PROJECT				DISCIPLINE			
SOPHIA WATERS - STAGE 3B				RETAINING WALL PLAN			
PLAN TITLE				PROJECT No. 190205(3B) - CENG - 103			
DISCIPLINE				NUMBER			
190205(3B) - CENG - 103				REV. H

## 3.0 PROPOSED AMENDMENTS

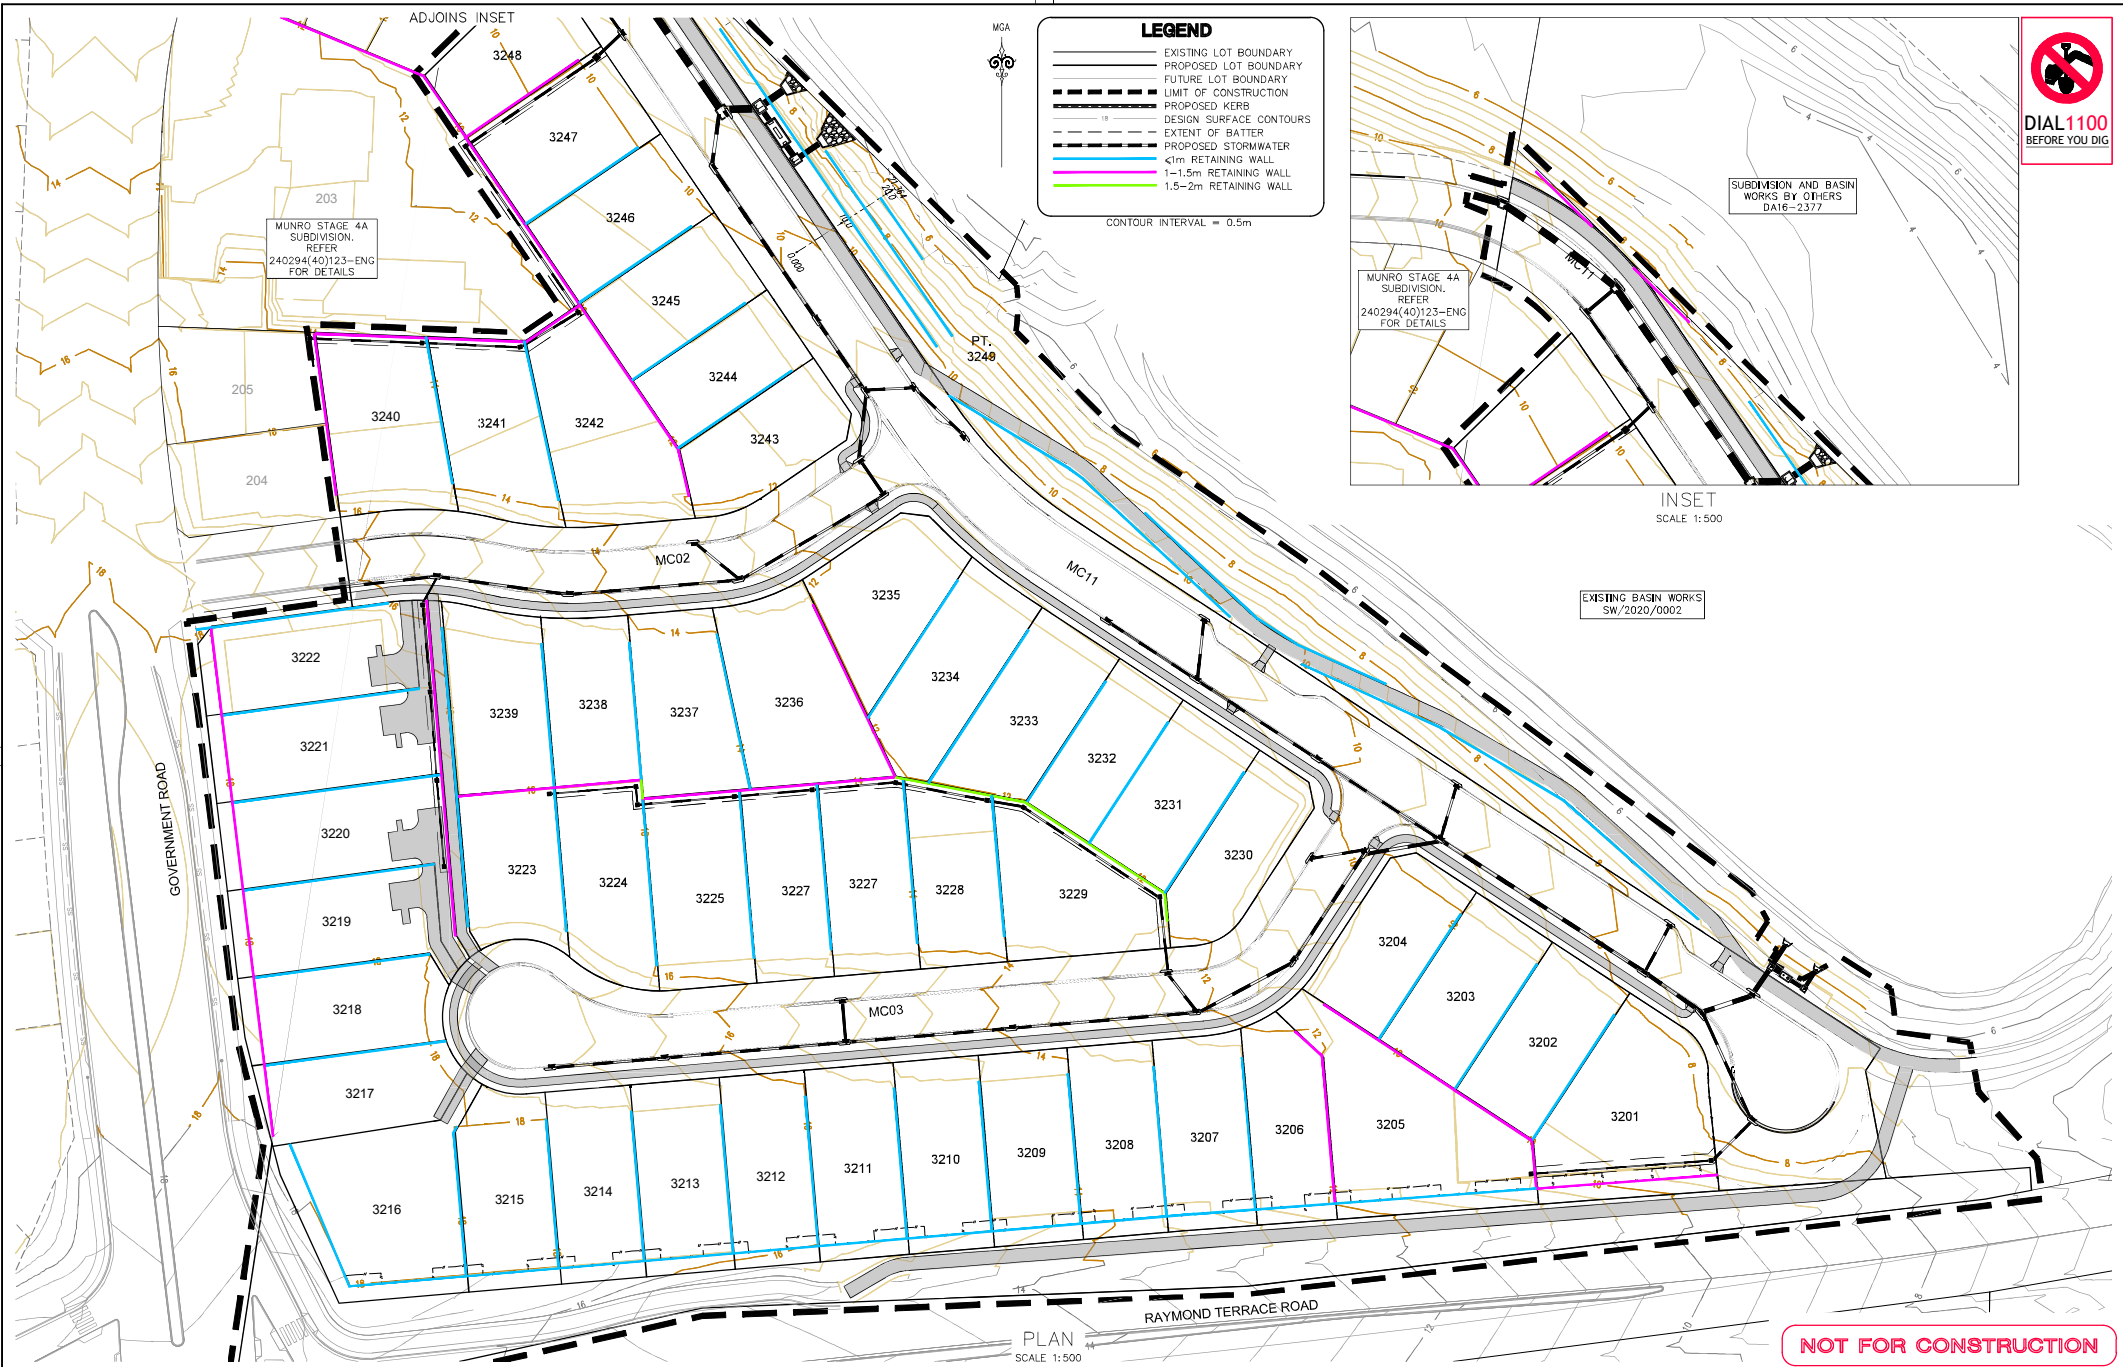
Revised retaining is required to deliver the abovementioned changes to the layout. Please Refer **Attachment D** for these changes.

Allam Property Group intend to leave wall heights several hundred millimetres above the pad level. This additional height is not acting as a retaining structure and should not be included in the measurement of maximum height. SWC plans will be submitted showing the difference between the top of wall and the "effective top of wall" to show what is acting as retaining.

32. Retaining walls on common boundaries shall be in accordance with the approved retaining plan. No walls shall exceed the maximum effective height of 1.5m.

Figure 2: Amended subdivision layout plan

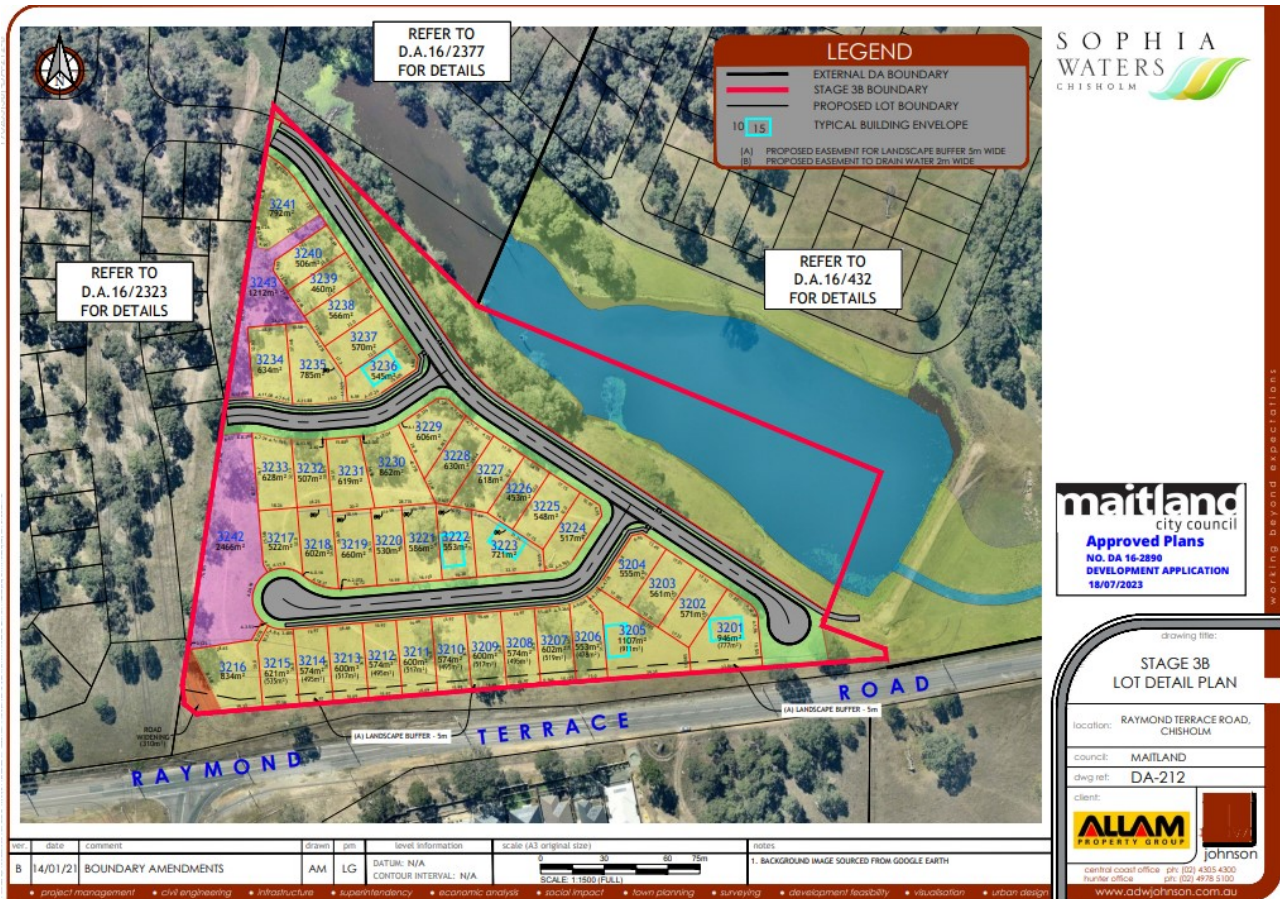
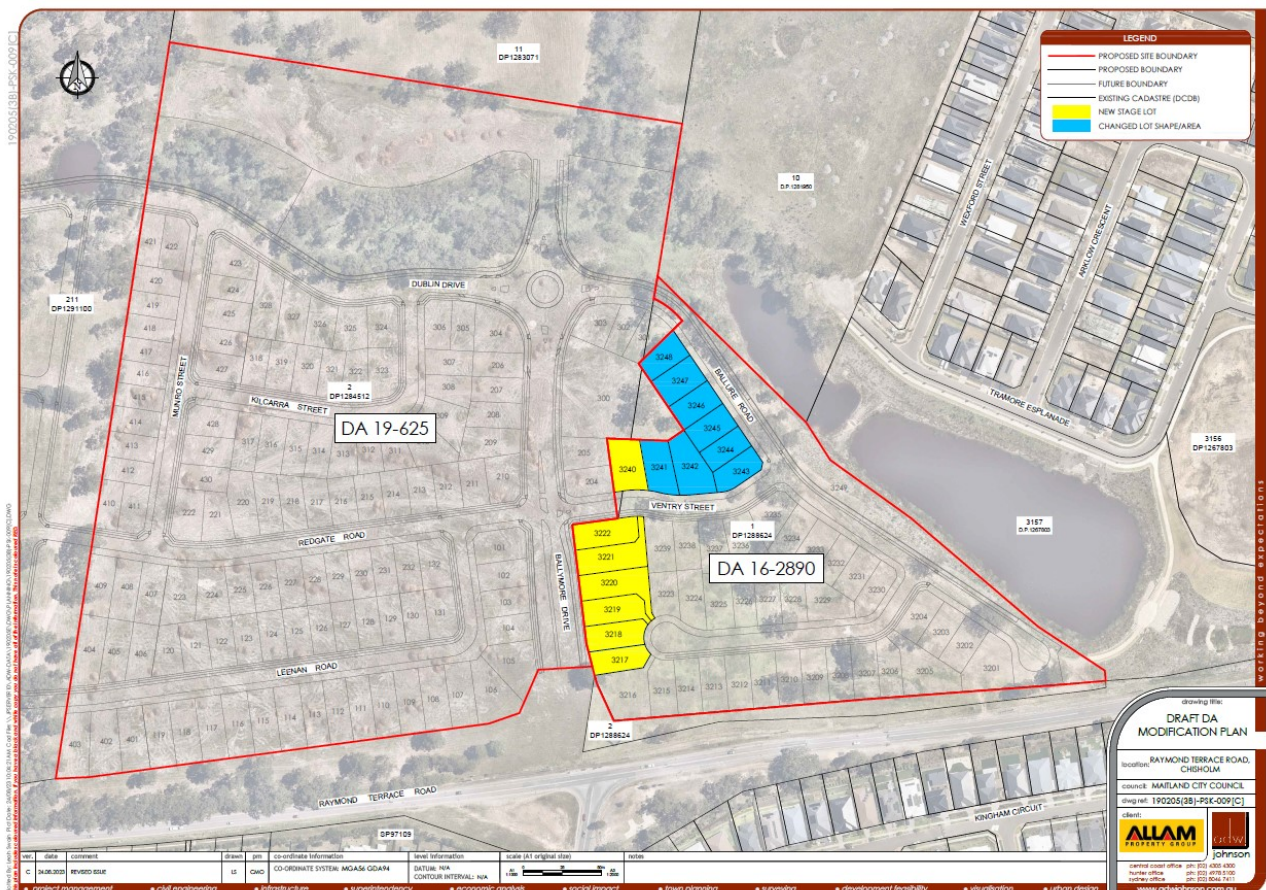
The current development description should refer to 40 residential lots (not 42) and two residue lots. As part of this modification, it is proposed to delete the two residue lots, Lot 3242 and Lot 3243 to be replaced by an additional 8 residential lots, resulting in 48 residential lots in total. Amending the development description will more accurately reflect the proposed number of residential lots and resolve the residual land between this development and the development to the west (DA/2019/652:2).

The proposed modification will result in the deletion of the two residue lots, Lot 3242 and Lot 3243 to be replaced by an additional 8 residential lots, resulting in 48 residential lots in total. In addition, residential Lots 3234 – 3241 have slightly been reconfigured. – refer **Figure 2** below and **Attachment B**.

*Subdivision of 1 Lot into **48** residential lots, Associated Vegetation Clearing, Earthworks and Construction.*
